Access Compliance Report

Public Rights-of-Way

Intersection ID: 8473	Main Street: BEECHWAY_CR	Cross Street: SPRINGVIEW_RD	Location: SE
ADA ID: AE819071761B	Ramp Type: Perp	Initial Pass/Fail: Fail	Overall Compliance: No
Severity Score: 35			
Codes/Mitigation Info/Possible Solution		Field Measurements/Component Compliance

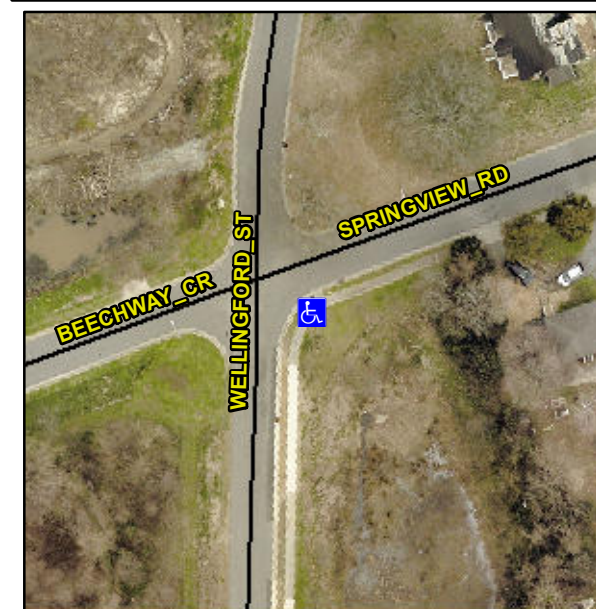
Not Found, R304.5.1, R304.2.2

Compliance	Description	Data	Compliance	Description	Data
N/A	Ramp Length (in)	49.0	No	Ramp Slope (%)	12.7
No	Ramp Width (in)	40.5	Yes	Ramp XSlope (%)	2.4
N/A	Flare Type LT	N/A	N/A	Flare Type RT	N/A
N/A	Flare Slope LT (%)	N/A	N/A	Flare Slope RT (%)	N/A
N/A	Flare Traversable LT?	N/A	N/A	Flare Traversable RT?	N/A
N/A	Landing Length (in)	N/A	N/A	DWS Provided?	N/A
N/A	Landing Width (in)	N/A	N/A	DWS Contrast?	N/A
N/A	Landing Slope (%)	N/A	N/A	DWS Length (in)	N/A
N/A	Landing X Slope (%)	N/A	N/A	DWS Full Width?	N/A
N/A	Landing Curb? (Y/N)	N/A	N/A	DWS Offset (in)	N/A
N/A	Shared Landing?	N/A			
N/A	Gutter Ponding?	N/A	N/A	Gutter Slope (%)	N/A
N/A	Gutter Lip Ht (in)	N/A	N/A	Gutter X Slope (%)	N/A
N/A	Painted X Walk1?	No	N/A	Painted X Walk2?	N/A
	X Walk 1 Direction	To NW		X Walk 2 Direction	N/A
N/A	X Walk 1 Width (in)	N/A	N/A	X Walk 2 Width (in)	N/A
	X Walk 1 Slope (%)	3.8		X Walk 2 Slope (%)	N/A
	X Walk 1 X Slope (%)	2.4		X Walk 2 X Slope (%)	N/A

Remove & Replace Entire Ramp.
